U.S. Department of the Interior BUREAU OF LAND MANAGEMENT Sundry Print Reports

Well Name: BURCH KEELY UNIT Well Location: T17S / R29E / SEC 24 / County or Parish/State: EDDY /

Notice of Intent

Type of Action: Plug and Abandonment

Burch Keely Unit #66 Eddy County, NM API# 30-015-03072

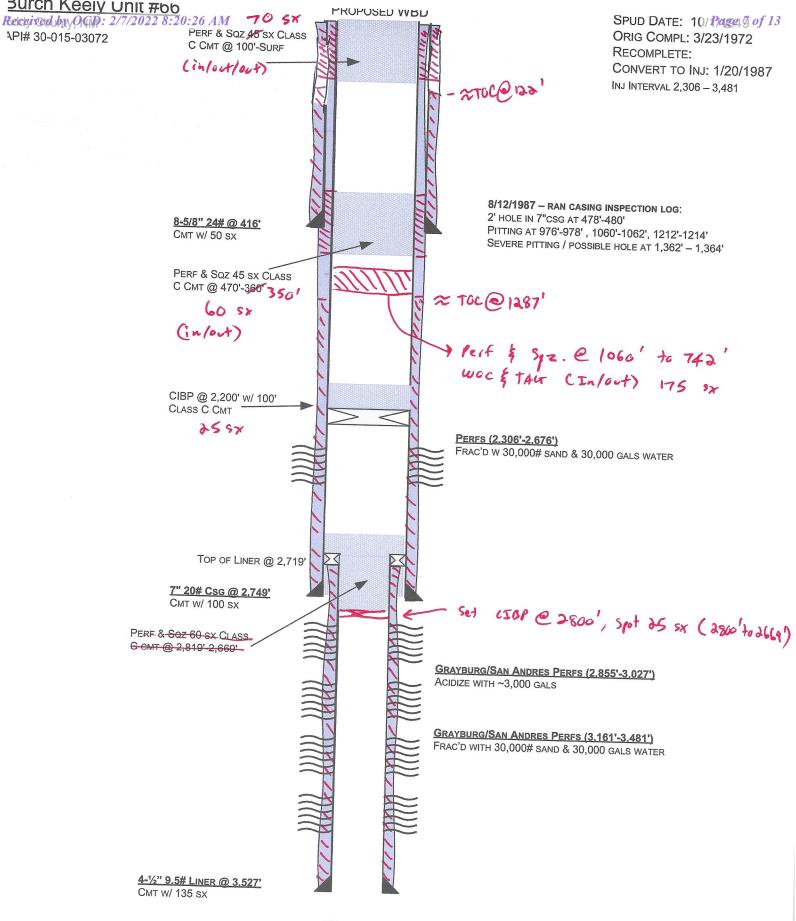
Set CIBP @ 2800', Spot 25 sx (2800' to 2669')

There of Spr. @ 1060' to 742' was FTAG (Infaut) 175 sx

If solid base no need to		
				Tag (CIBP present		
				and/or Mechanic al Integrity	8	
				Test), If Perf & Sqz then		Set CIBP at 2800' on top of open perforations in lieu
				Tag, Leak Test all CIBP if no		of a cement balance plug. Onshore Order 2.III.G.2, Spot from
CIBP Plug	2765.00	2800.00	25.00	Open	0.7.00	2800' to 2669'. WOC
Perforations Plug (If No CIBP)	2805.00			Perforatio Tag/Verify	25.00	and Tag
Perforations Plug (If No CIBP)	3111.00			Tag/Verify		Not Necessary Not Necessary
				If solid		Not Necessary
				base no

Sundry ID	2653714					
Plug Type	Тор	Bottom	Length	Tag	Sacks	s Notes
Surface Plug Top of Salt @ 405	0.00			Tag/Verif	70.00	Perf and Squeeze at 100' to Surface. Verify at surface. (In/Out/Out)

- op or our @ 403	350.95	455.00	104.05	Tag/Verif	/	
Shoe Plug Base of Salt @ 800	366.00 742.00	466.00		Tag/Verify		Perf and Squeeze at 470' to 350'. WOC and Tag (In/Out)
